IN REPLY REFER TO:  
NCPC File No. ZC #08-06A

RE: NCPC Comments on Proposed Text Amendments to DC Zoning Regulations

## **APPENDIX A**

### **Visual Modeling Study for North Capitol Street**

### **Visual Modeling Study for Independence Avenue**

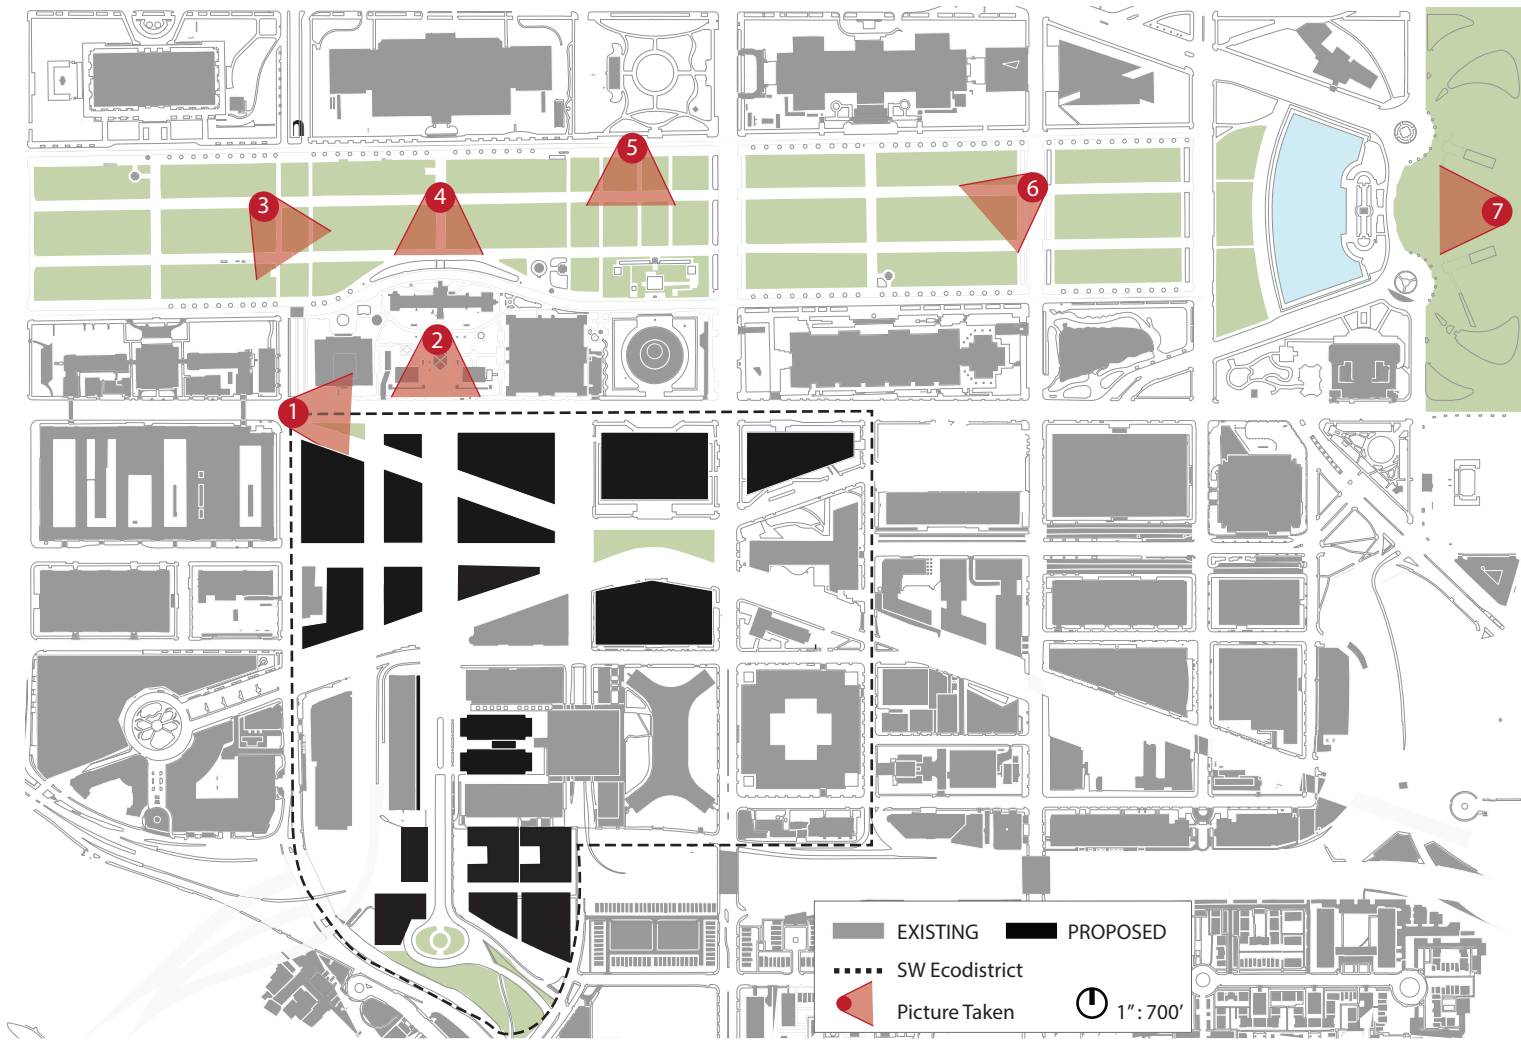
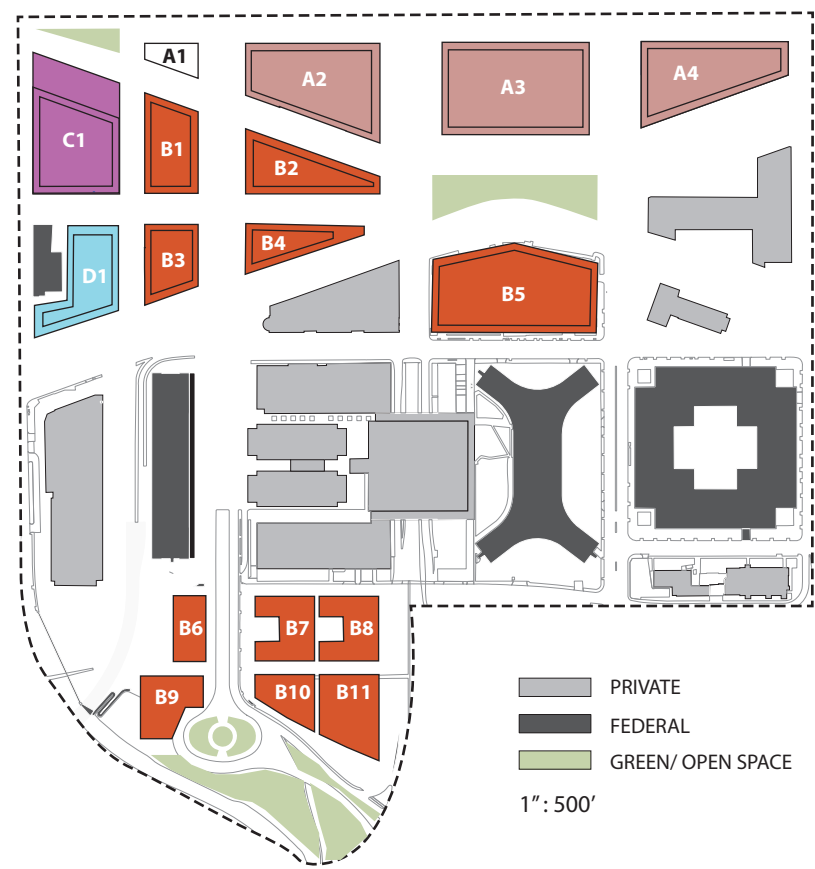
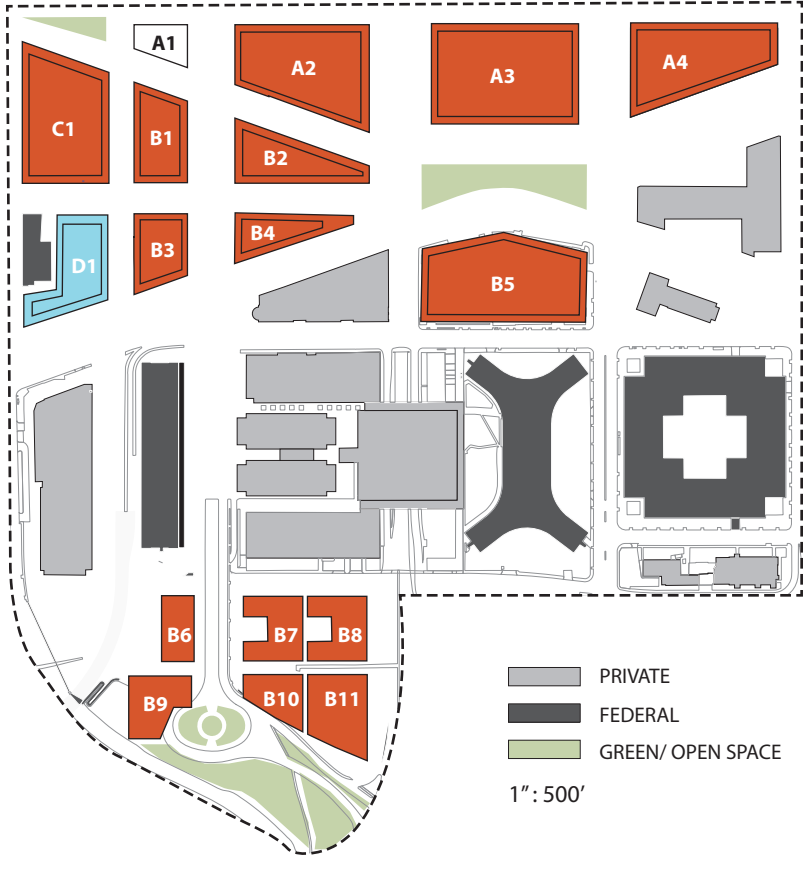
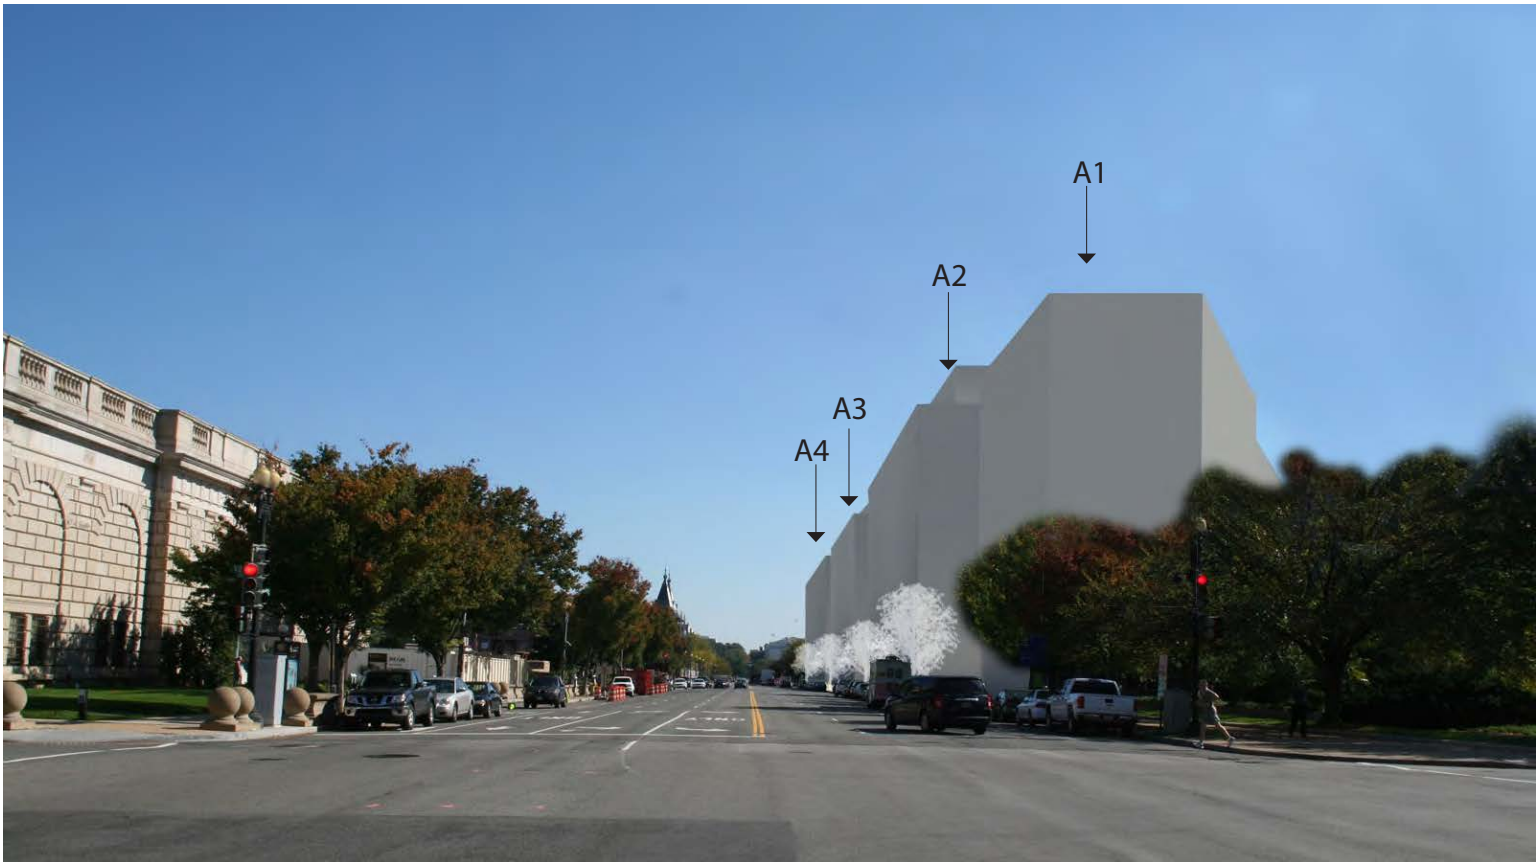
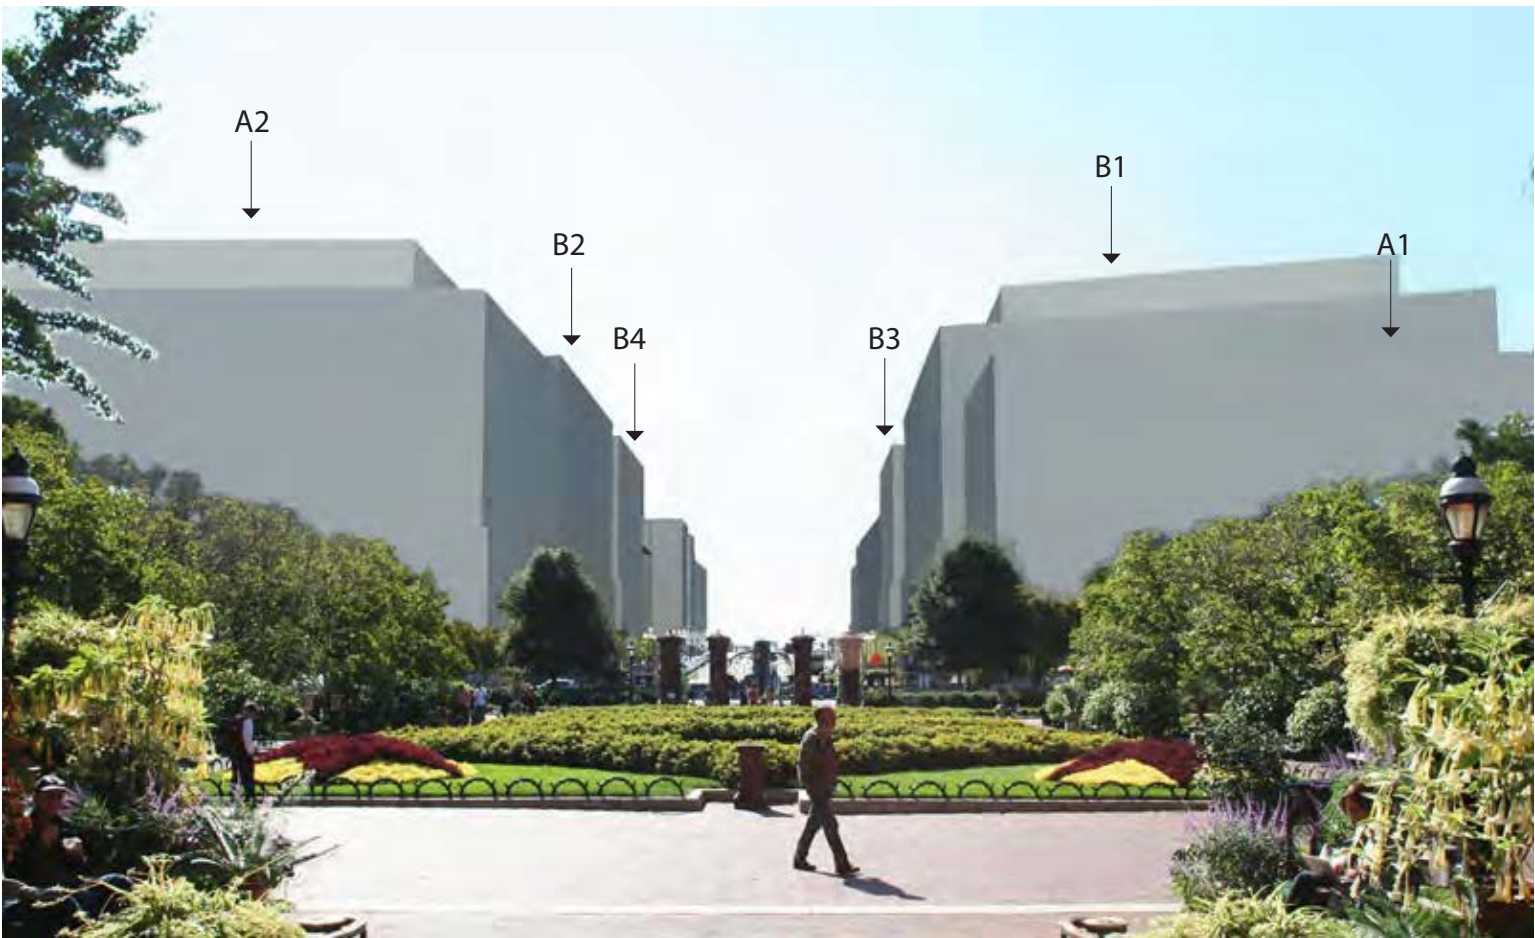
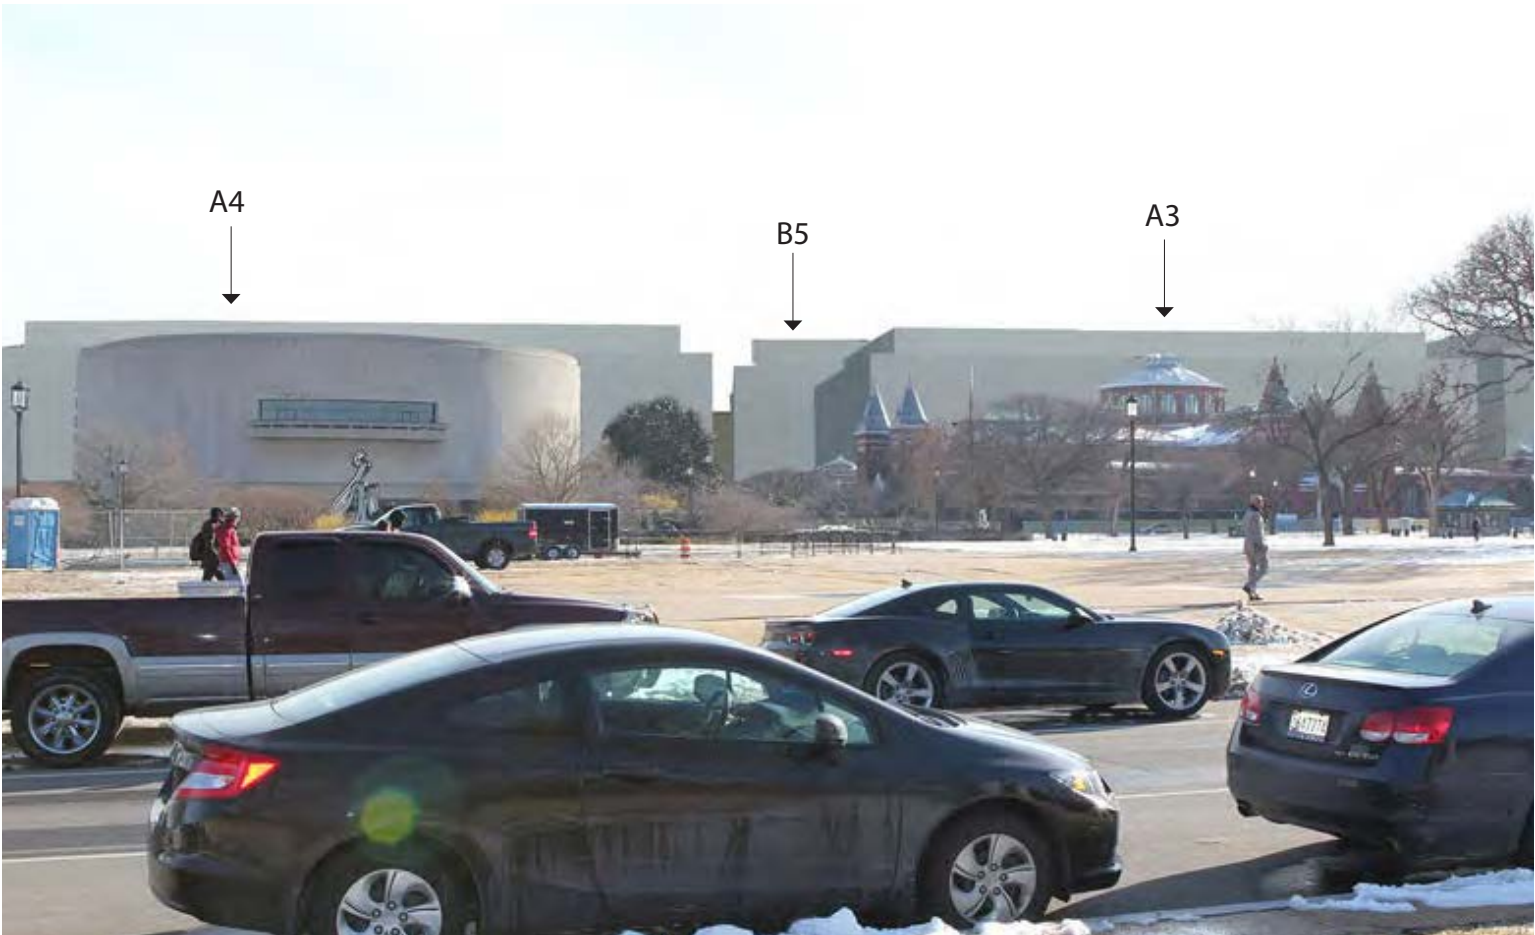
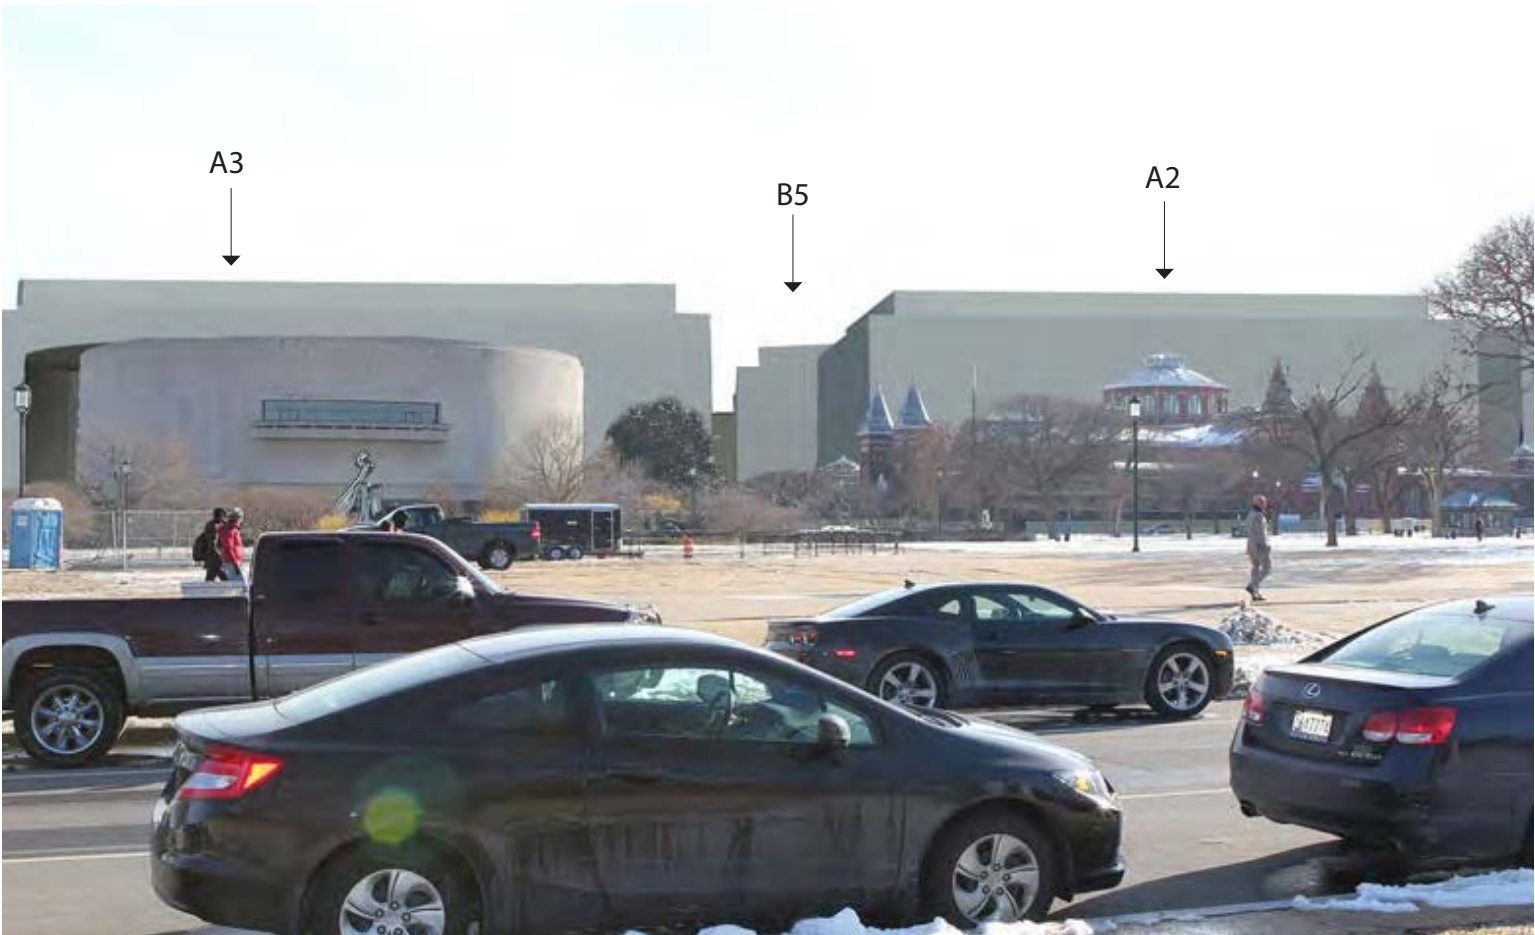
As shown in Appendix A, the proposed D-8-B-1 zone allows for 130' buildings with an additional 20' penthouse (setback at a 1:1 ratio) at the property line. As proposed, this will impact the character of the Mall and in particular the views of the Smithsonian Castle when standing in the center of the Mall. It also impacts the urban design of Independence Avenue by creating 150' buildings (penthouse included) on the south side of the avenue when the Smithsonian buildings across the street are 50-80' in height.

- **Allow a maximum allowable building height of 110' (plus the 20' penthouse setback at a 1:1 ratio) for the area on the south side of Independence Avenue shown in Appendix A. While this would still result in new development being seen from the Mall (especially behind the Smithsonian Castle), it would lessen the impact of the proposed D-8-B-1 zone.**
- **Setback the buildings 88' from the right-of-way centerline on Independence Avenue to align with the corner of the USDA building at 12th and Independence. This would be similar to the setbacks of the Smithsonian buildings and help to mitigate the proposed height. See Appendix A for more detail.**

**Independence Avenue Overlay Zone**

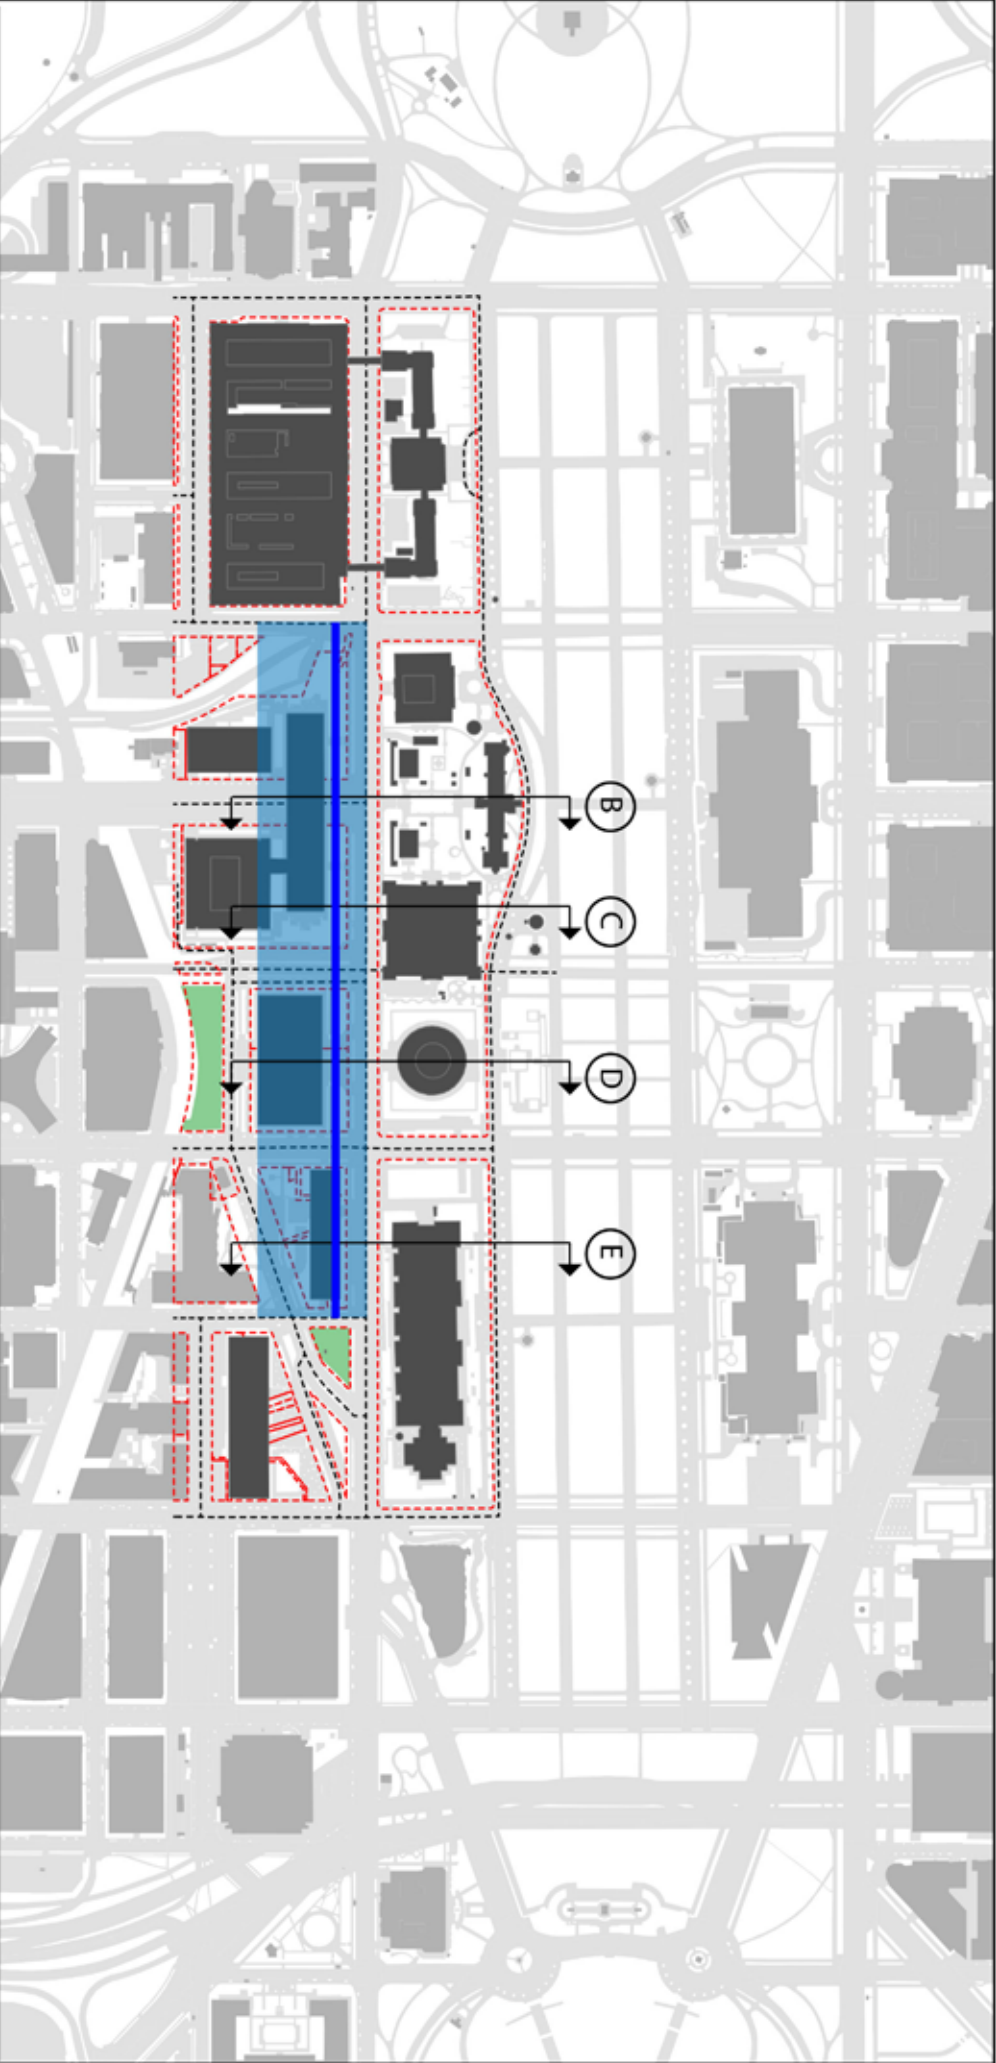
The overlay zone allows for 110 foot building height + 20 foot penthouse with a 1:1 setback. The overlay zone is bounded by the 12th Street SW ROW centerline to the west, 6th Street SW ROW centerline to the east, Independence Avenue SW ROW centerline to the north, and the southern boundary of the overlay measures 362 feet south of the Independence Avenue SW ROW centerline. The southern boundary also aligns with the southern building edge of the FAA Orville Building.

The setback line is 88 feet south of the Independence Avenue ROW centerline
